ARCHITECTURAL REVIEW FINDINGS AND DECISION

**** APPROVAL WITH CONDITIONS ****

Case #: AR-15-0020
Project: Horizon Community Church Modular Classroom Building
Location: [23370 SW Boones Ferry Rd](#) (Tax Lot 2S1 35D 000106)
Applicant: Scott Platt, Facilities Director, Horizon Community Church (503-729-0173; applicant project no. 15-1039)

SITE PLAN - MODULAR CLASSROOM

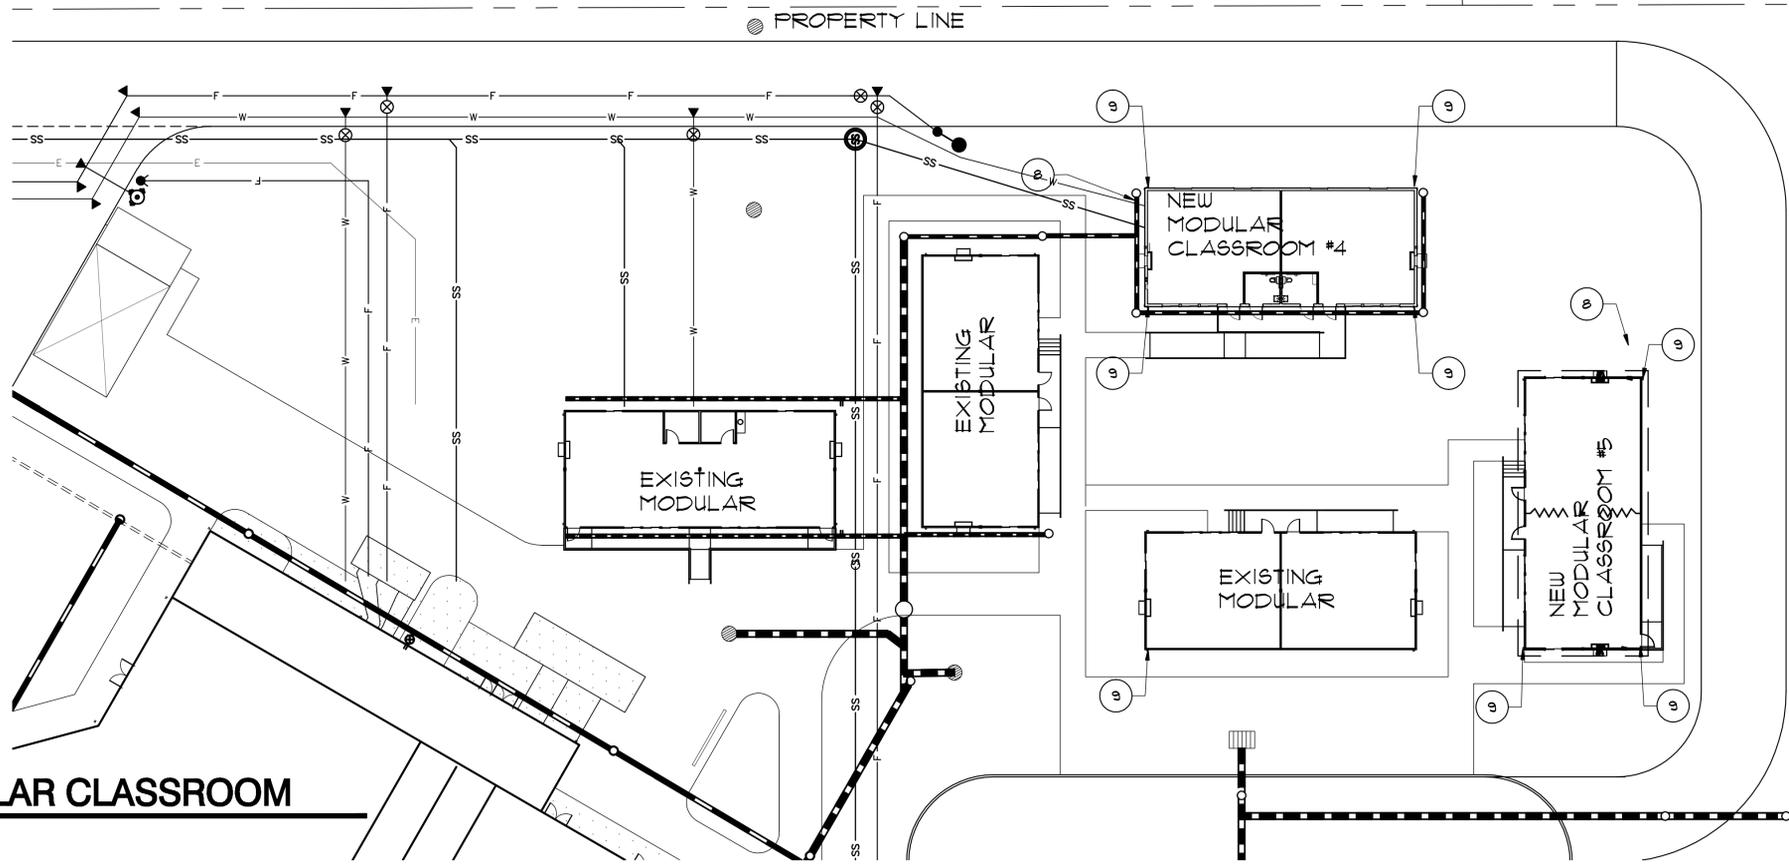
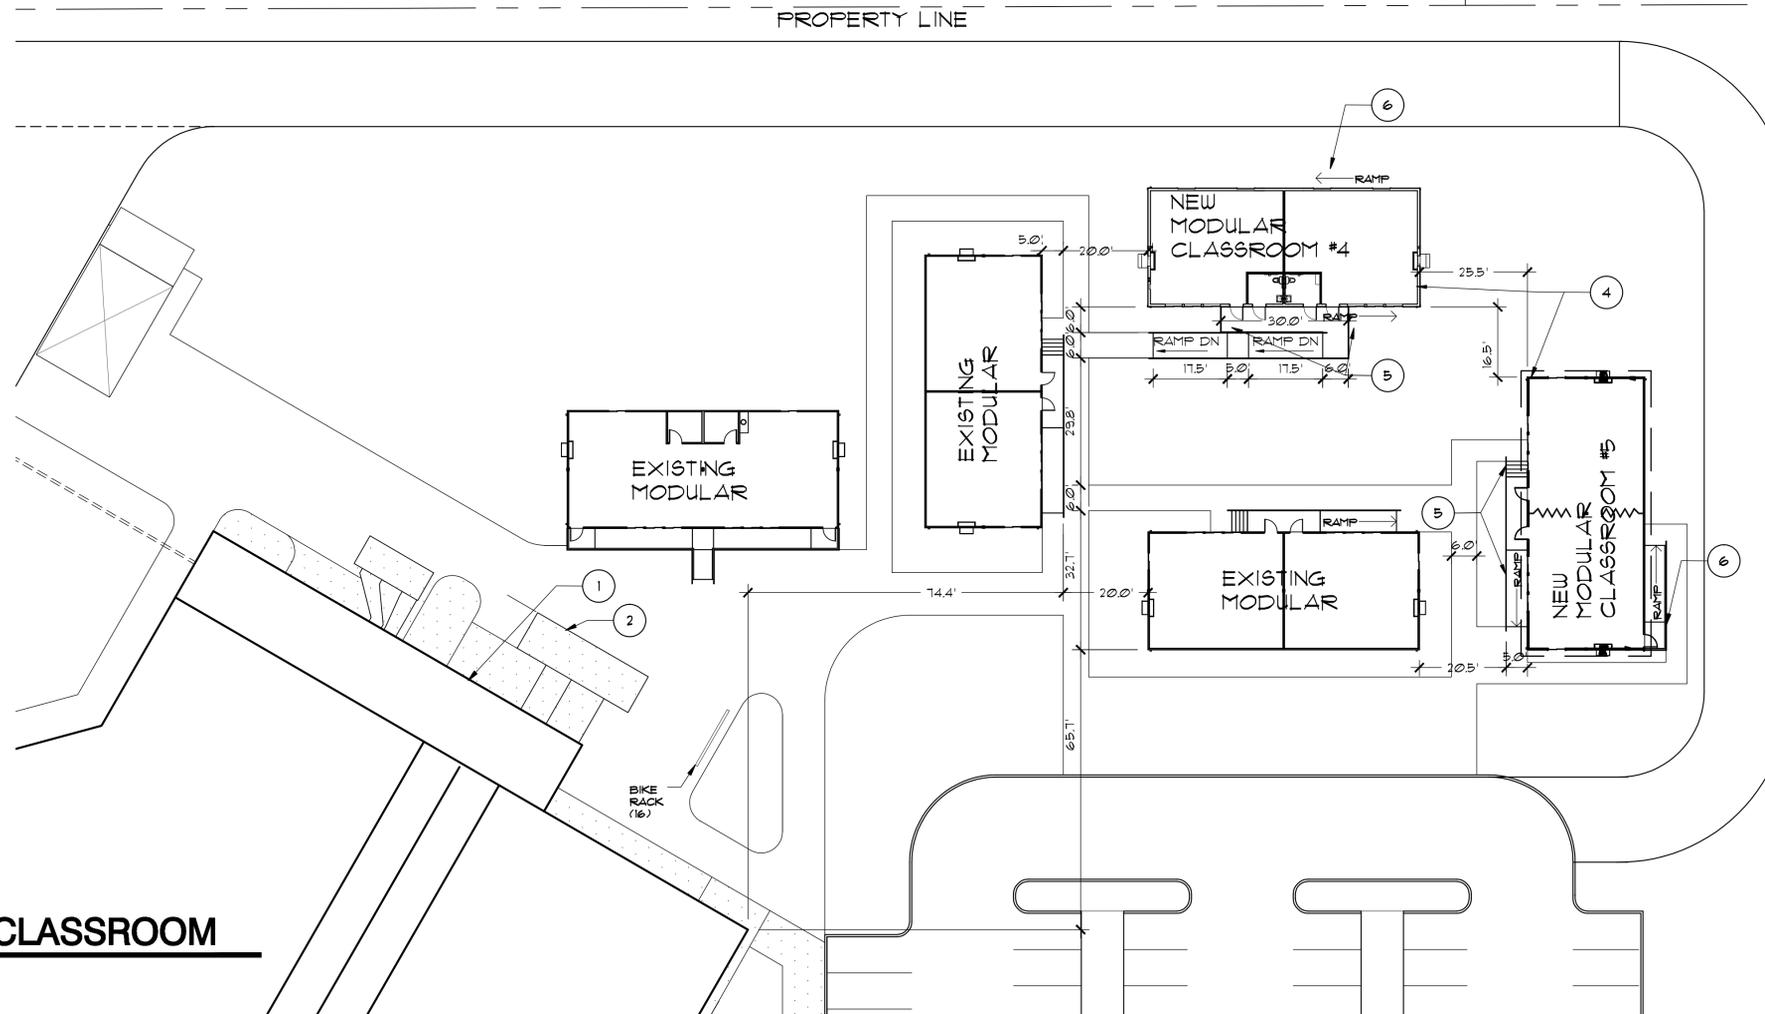
Because the site plans do not indicate the total square footage of landscaping or a percentage of Lot 106, staff cannot determine compliance and so is applying a condition.

Because the site plans do not indicate the percentage of landscaping, if any, that is unvegetated area of bark chips, rock or stone, staff cannot determine compliance and so is applying a condition.

Because the site plans do not indicate irrigation with an automatic underground or drip irrigation system, the requirement is not met, and staff is applying a condition.

The site plans do not note an existing bicycle parking supply or tabulate the square footages of the primary uses of the property for a church and a school. Without this information, staff is unable to calculate a minimum required bicycle parking supply and compare it with any existing supply to determine if any existing bicycle parking can accommodate the proposed modular classroom building. For this reason, staff is applying a condition.

Because the site plans indicate no existing or additional bicycle parking, staff is unable to determine compliance and so is applying a condition.

The site plans note that the Horizon campus has a total of 451 parking spaces, and though the supply appears sufficient the plans do not tabulate the square footages of the primary uses of the property for a church and a school. Without this information, staff is unable to calculate a minimum parking requirement and compare it with the existing supply to determine if existing parking can accommodate the proposed modular classroom building. For this reason, staff is applying a condition.

- The applicant shall revise the site plans to note the square footage of landscaping on the subject tax lot and its percentage of the lot.

- The applicant shall revise the site plans to note the percentage of landscaped area covered with unvegetated areas of bark chips, rock or stone.

- The applicant shall revise the site plans to note landscaped areas irrigated with an automatic underground or drip irrigation system.

- The applicant shall revise the site plans to indicate total on-site building square footage and its division by the primary uses of the subject property, church and school, and tabulate the minimum required bicycle parking supply and compare it with any existing supply.

- The applicant shall revise the site plans to indicate bicycle parking facilities that meet the security, dimensional, and signage requirements.

- The applicant shall revise the site plans to indicate total on-site building square footage and its division by the primary uses of the subject property, church and school, and tabulate the minimum required parking supply and compare it with the existing supply.
